PRODUCT CHANGE NOTICE

**Alternate Manufacturing Site
for Assembly of the Listed
Intersil SOT23 Packaged
Products**

**Refer to:
PCN13022**

Subject: **Alternate Manufacturing Site for Assembly of the Listed Intersil SOT23 Packaged Products – Carsem (CAM) Ipoh, Malaysia**

PCN13022 – Current POD SOT23 5L

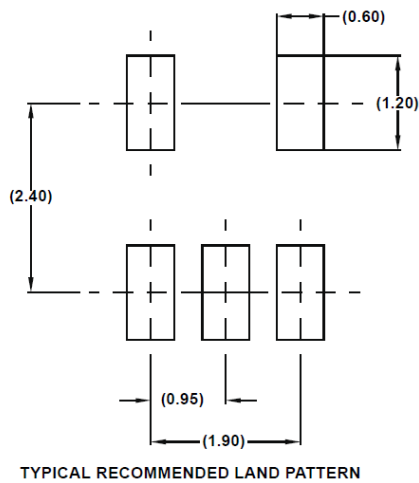
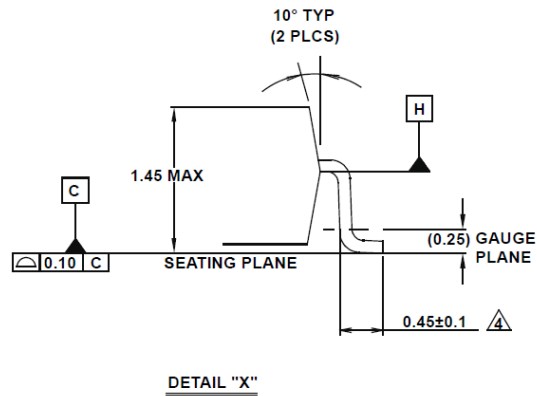
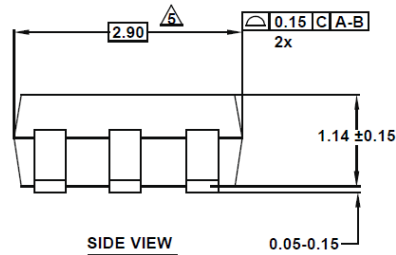
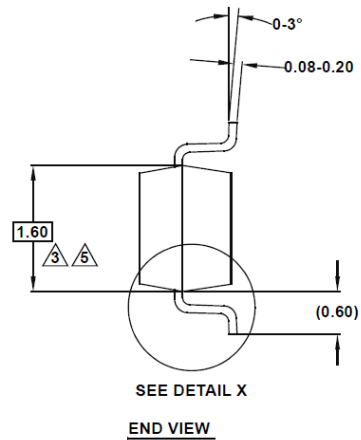
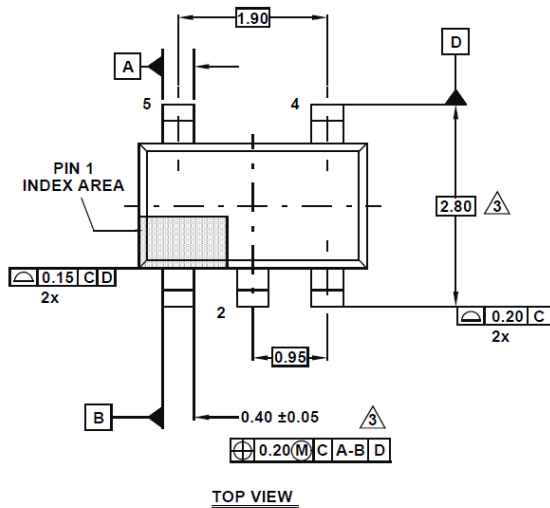
The Carsem (CAM) facility is ISO9001:2008, ISO/TS16949:2009 and ISO14001:2004 certified. The CAM facility is qualified as a supplier to Intersil for performing assembly of packaged products, including the SOT23 package style. There will be no change in the die attach, bond wire (material or diameter), frame material, or moisture sensitivity level (MSL). The packaged devices will require minor dimension changes to the package outline drawings (POD). However, there is no change in the recommended PCB land dimensions. The affected PODs and a summary containing a list of products along with the current and new PODs are included for reference.
